LEGAL DESCRIPTIONS

THIS DESCRIBED PARCEL CONTAINS 76.23 ACRES OF LAND AS SURVEYED, BEING SUBJECT TO AND TOGETHER WITH ANY EASEMENTS, RESTRICTIONS, OR RESERVATIONS AFFECTING THIS PARCEL.

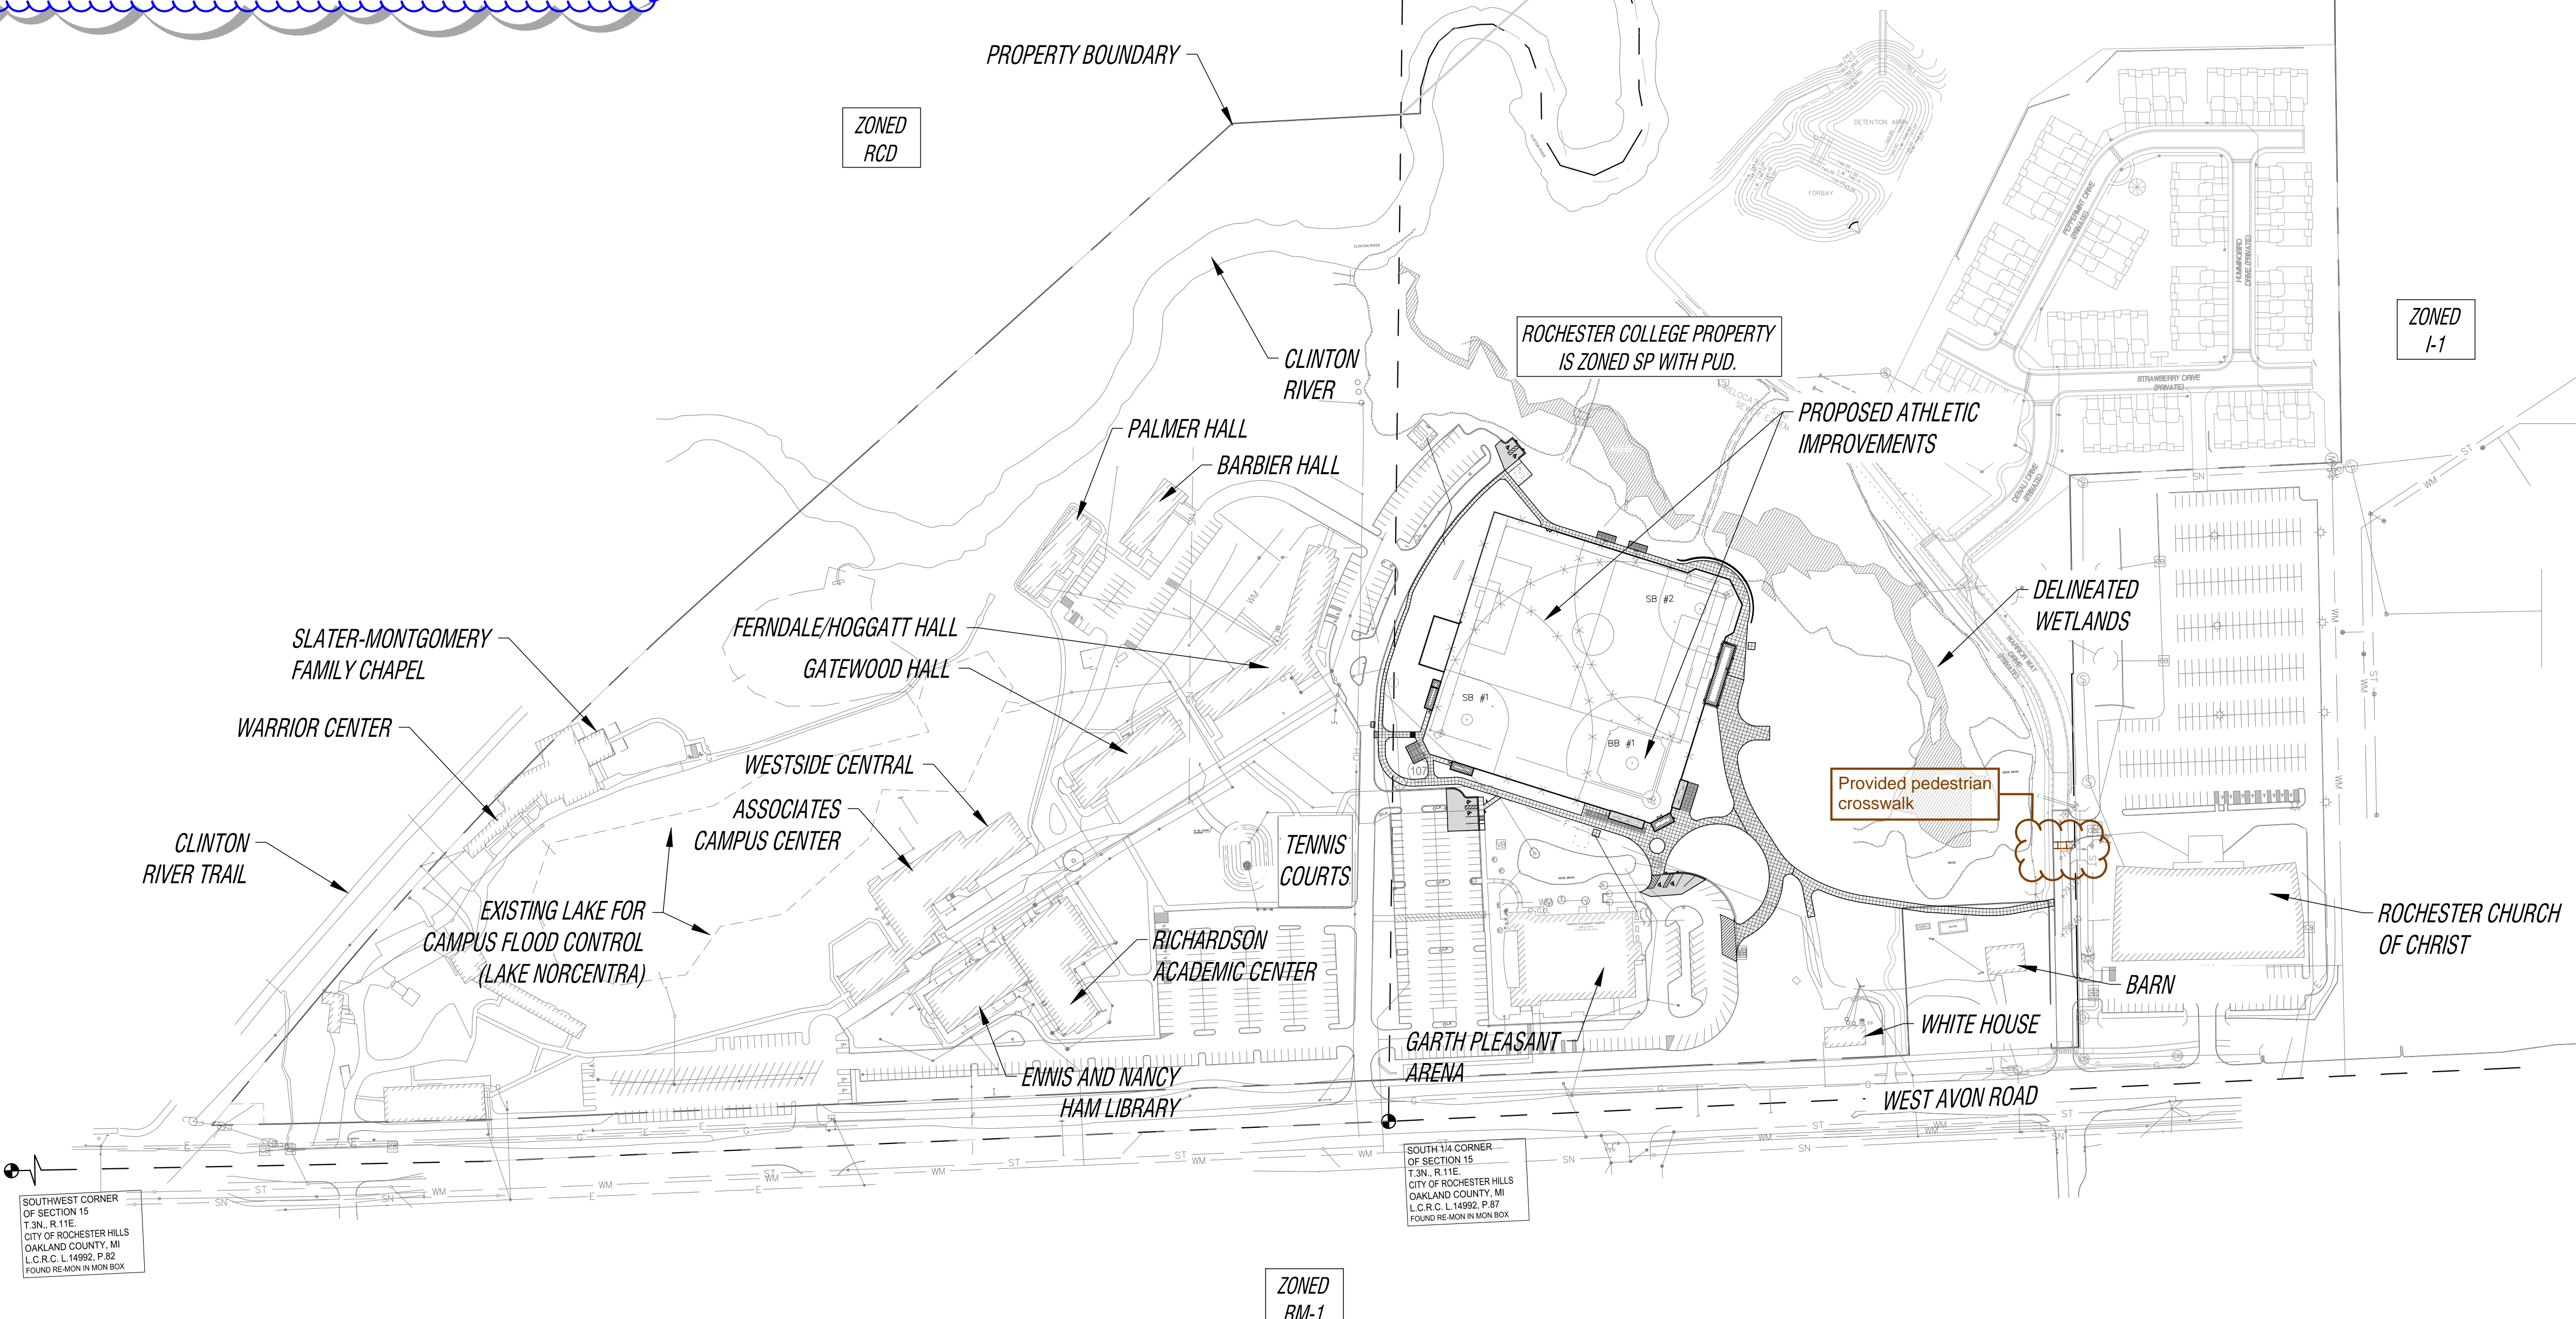
The applicant needs to submit a Land Improvement Permit (LIP) application with engineer's estimate, fee and construction plans to proceed with the construction plan review process.

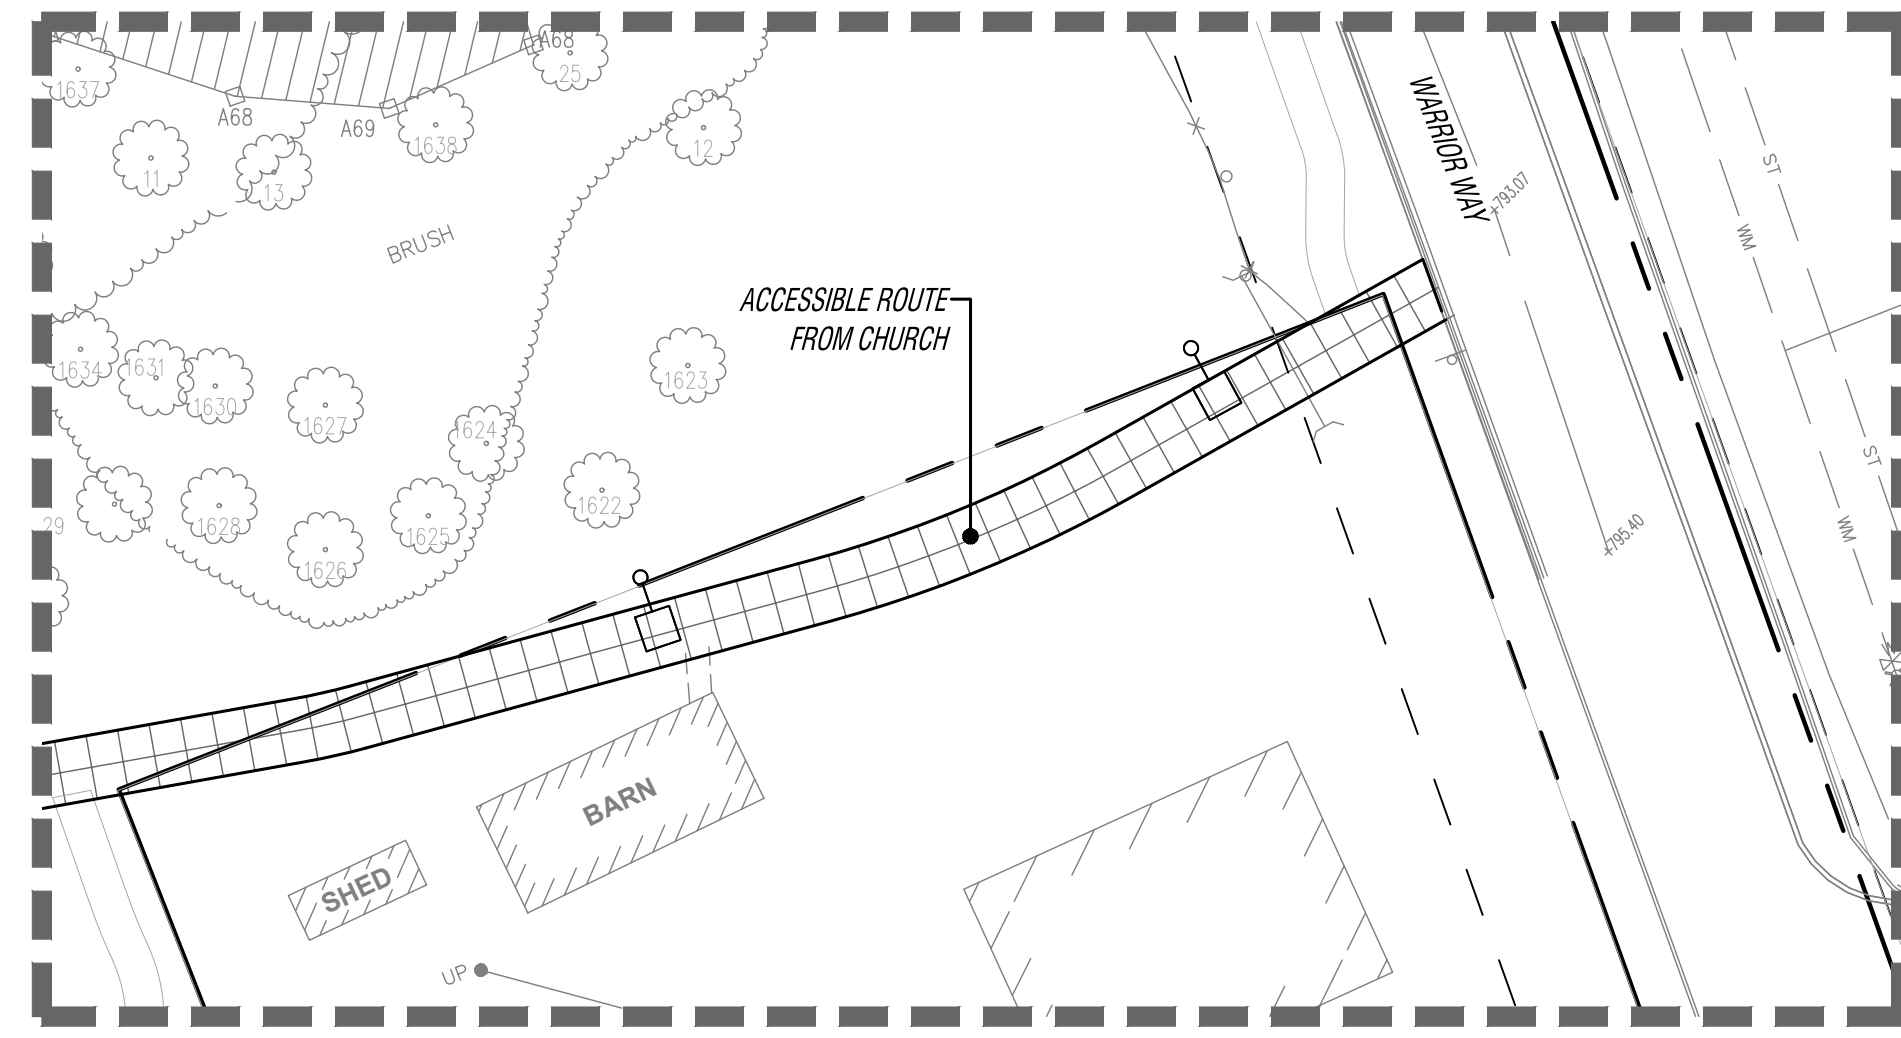
ISSUE DATE	ISSUED FOR
10/5/22	BIDS
10/24/22	ADDENDUM #1
11/23/22	PERMITS
12/2/22	SITE PLAN RESUBMITTAL
DRAWN	JA
CHECKED	
APPROVED	JA

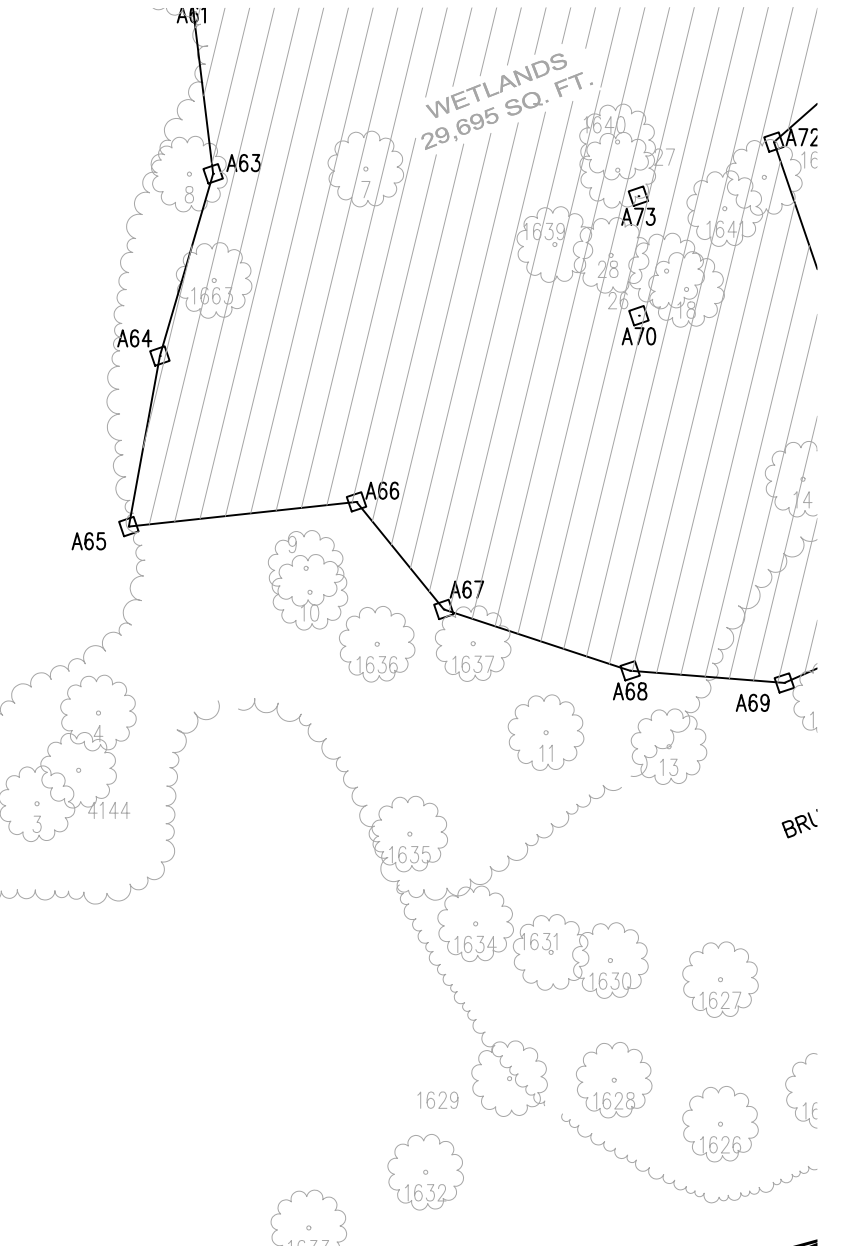
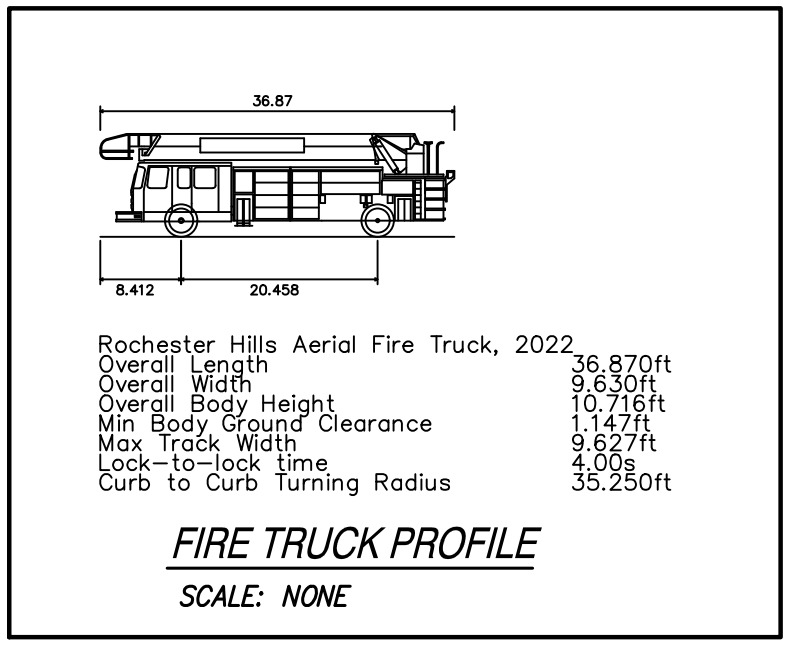
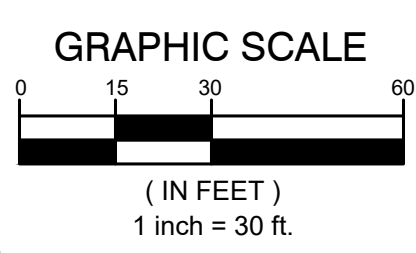
ISSUE DATE	ISSUED FOR
10/5/22	BIDS
10/24/22	ADDENDUM #1
11/23/22	PERMITS
12/2/22	SITE PLAN RESUBMITTAL
DRAWN	JA
CHECKED	
APPROVED	JA
